**Proof of Evidence by Councillor Simon Pike  
on Outline Sustainable Drainage Strategy Issue 4  
Land at Lawrences Lane, Thatcham, West Berkshire**

Change of use to 7 no. Gypsy/Traveller pitches comprising 7 no. static caravans,  
7 no. day rooms, 7 no. touring caravans and associated works

**Appeal Reference: APP/W0340/W/22/3292211**

(West Berkshire Council Planning Application No: 21/02112/FUL)

Figure 28.13 Head–discharge relationship for a simple orifice plate (courtesy Hydro International)

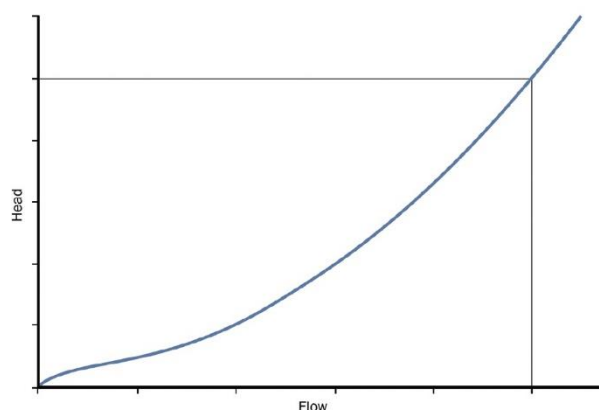
11. The two flow control chambers between pitches 4 and 5 and between pitch 7 and the detention pond are described in the assumptions for the Microdrainage simulations as orifice devices with elevation differences of 70mm and 60mm. As shown in the graph<sup>4</sup>, the flow of an orifice flow control chamber increases with the head, and therefore reduces as the drainage tanks empty.

12. It is unclear whether the Microdrainage analysis takes account of water already in the storage system at the start of the event (there is a parameter 'durations', with values up to 7 days, but it is not explained when this starts).
13. Therefore, when an extreme event occurs, the storage system could still be partially full with water from previous rainfall, and its capacity would be reduced accordingly. It appears that this may not have been taken into account in the analysis.
